CITY OF GLENDALE, CA

DESIGN REVIEW STAFF REPORT – MULTI-FAMILY / MIXED USE

June 14, 2021	426 Ivy Street
<i>Decision Date</i>	<i>Address</i>
Administrative Design Review (ADR)	5695-007-009
<i>Review Type</i>	<i>APN</i>
PDR2105036	Haykanush Ananyan
<i>Case Number</i>	<i>Applicant</i>
Danny Manassarian	Suren Zakaryan
<i>Case Planner</i>	<i>Owner</i>

The applicant is proposing to demolish an existing 1,984 SF two-story, single family house (built in 1910) and construct a new four-unit, multi-family residential building on a 6,250 SF lot in the R-1250 (High Density Residential) Zone, located at 426 Ivy Street.

1 PARKING LEVEL FLOOR PLAN
1/4" = 1'-0" 0' 4' 8' 16'

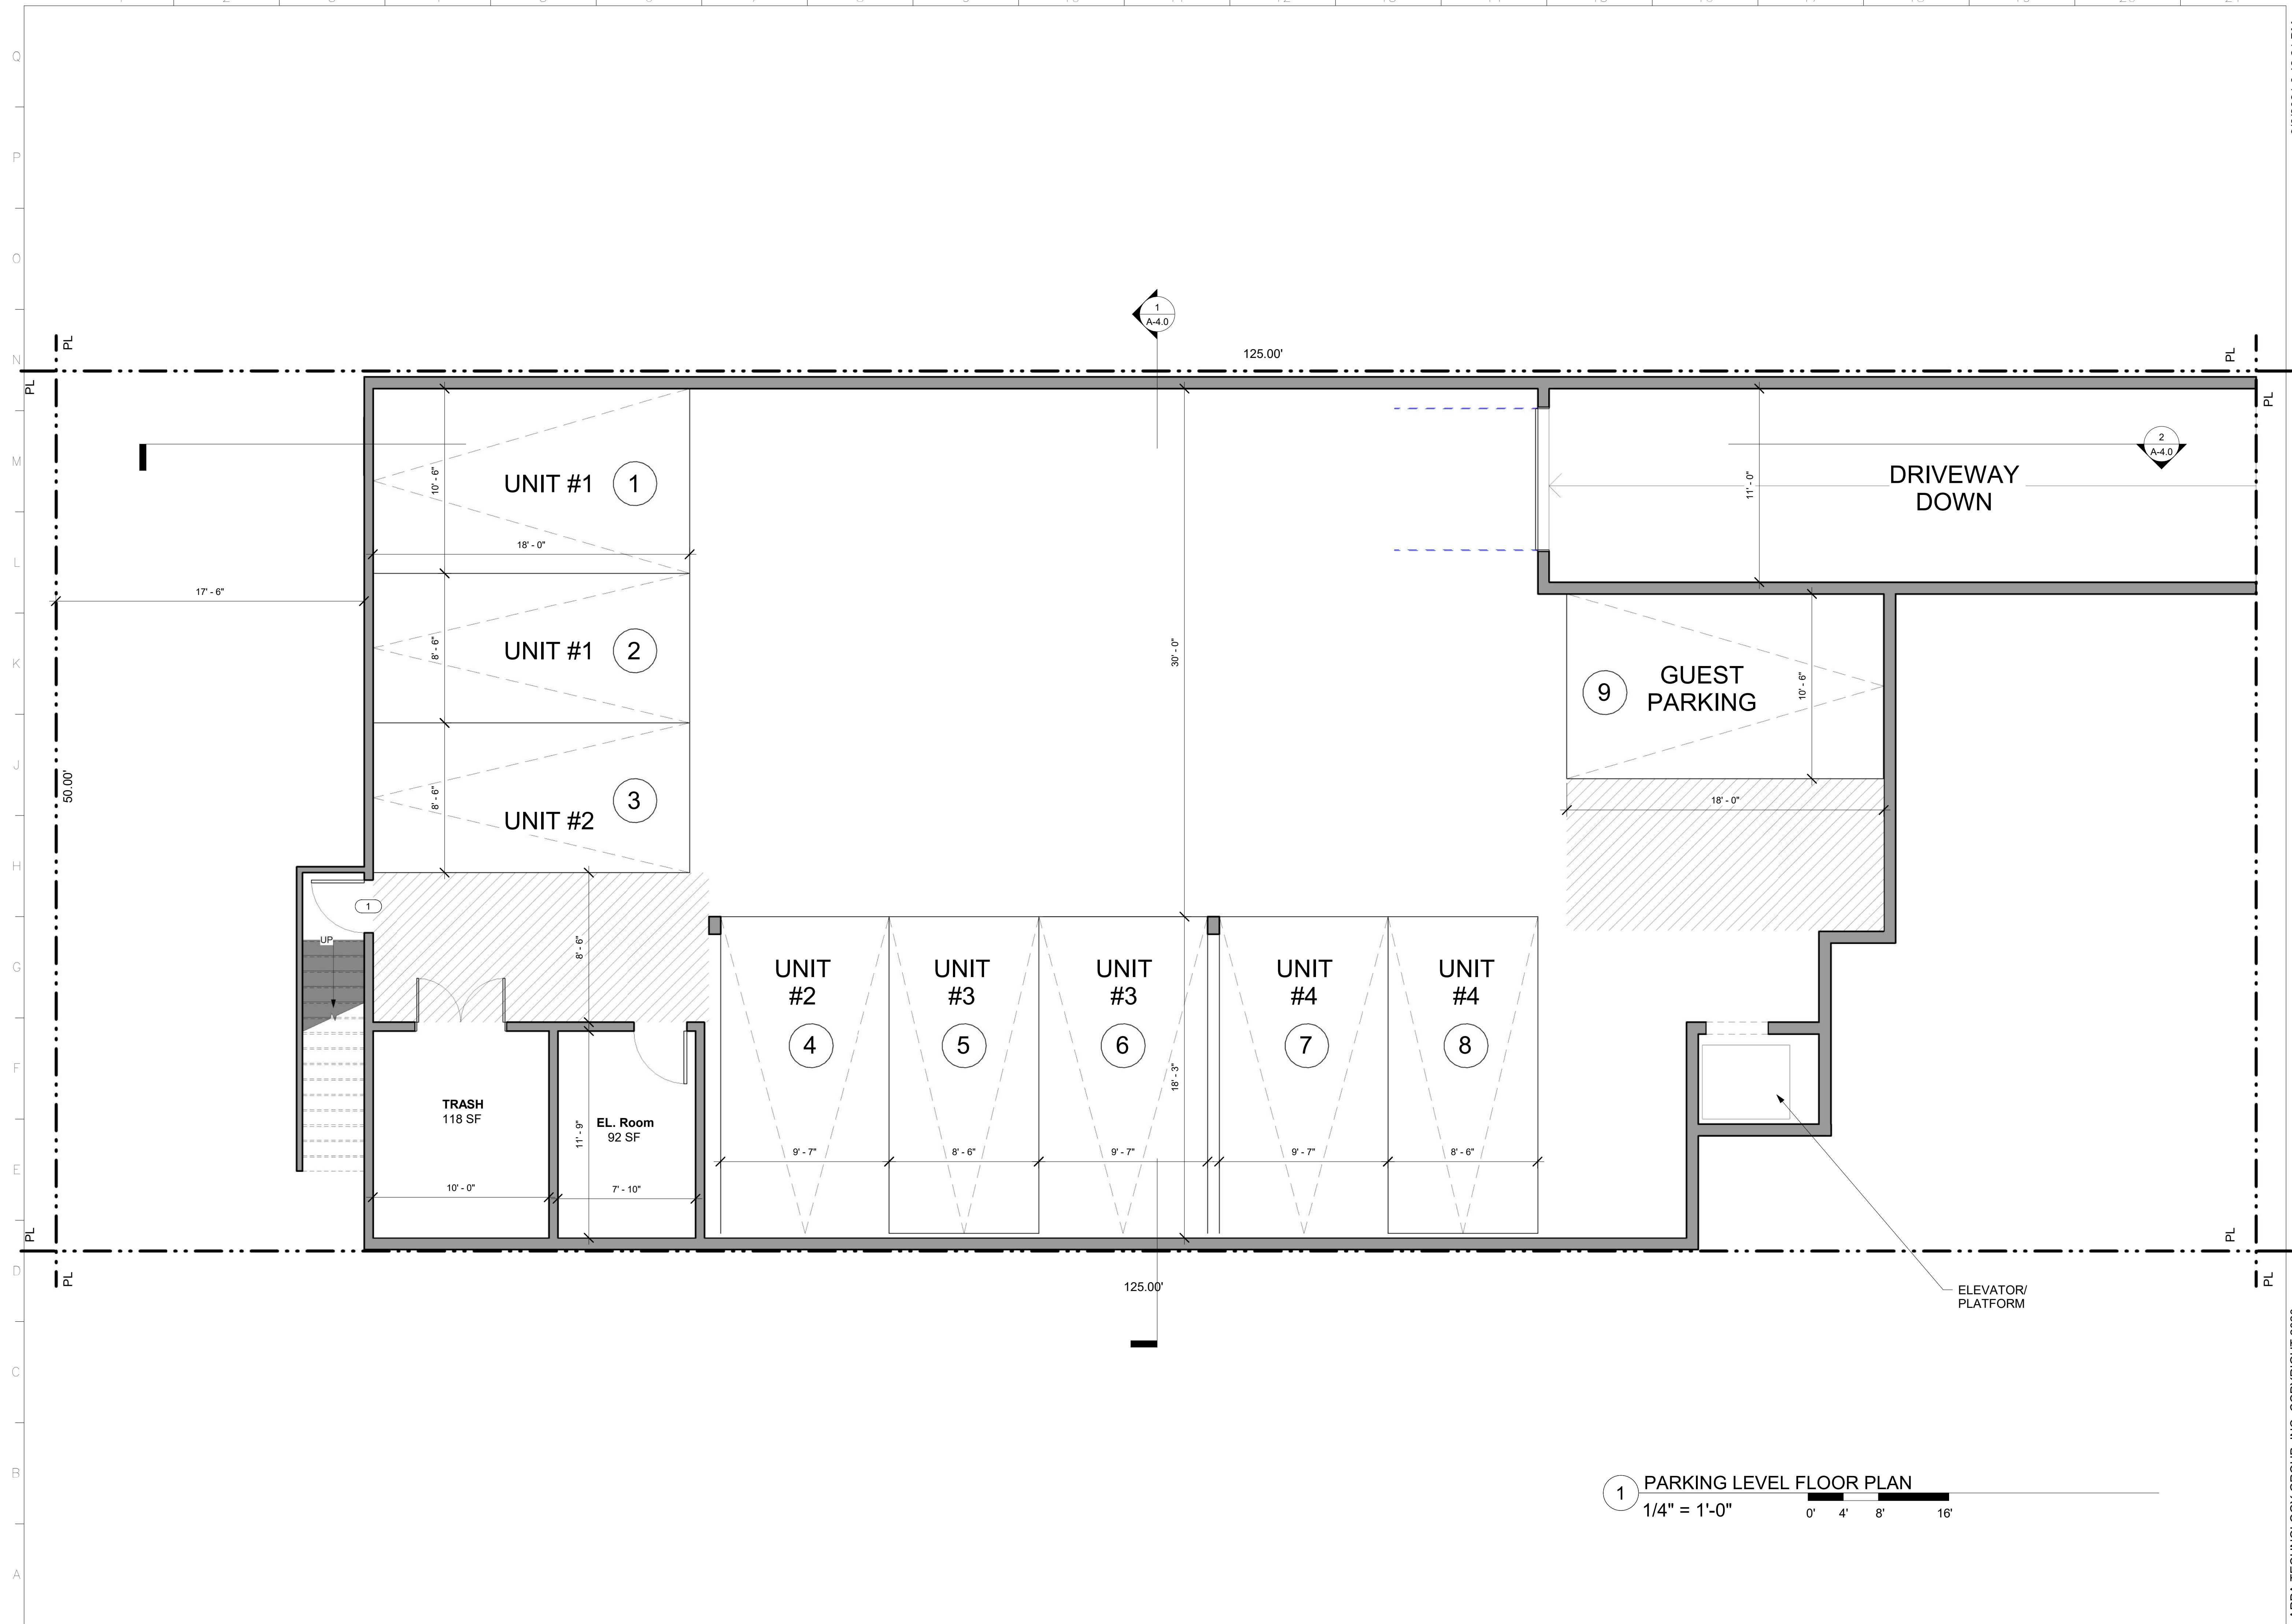
Window details are missing from plans. Applicant shall revise window schedule to show the material, frame type, and sill and frame detail for staff review.

- All new windows will be a combination of casement (only at the front façade), fixed, and slider operations. The proposed fenestration is compatible with the modern style of the building. A condition of approval has been added to revise the window schedule to show the material, frame type, and sill and frame detail for staff review.

1. New landscaping to be drought tolerant.
2. Revise window schedule to show the material, frame type, and sill and frame detail for staff review.
